# Development Management Sub Committee

20/01410/PPP

at 43 Main Street, Edinburgh, EH4 5BZ

Planning application for residential development including associated access, parking, infrastructure, and landscaping.

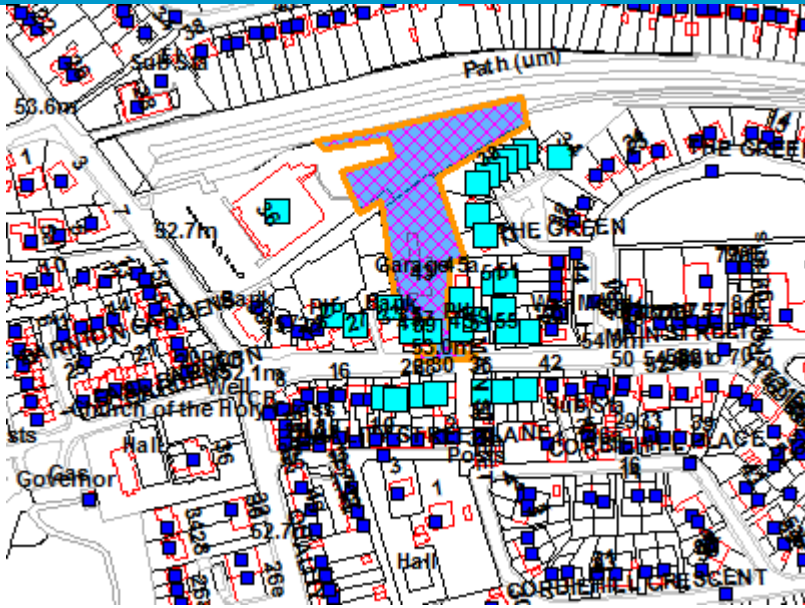
IV. *The principle of vehicular access from Main Street is agreed, again the design of which would be agreed through subsequent applications. Any future junction design should be in-line with the Edinburgh Street Design Guidance and promote priority for vulnerable users.*

*Graham is better placed to comment on the legal opinion prepared by Morton Fraser but really the status of the route as a PROW is not the main issue here. Access is currently available across this site and this will remain the case following the development. The comments received focus on the quality of this access and I see that recent design changes reflect these comments with the two 90 degree bends now changed to 45 degrees to provide better visibility at these points.*
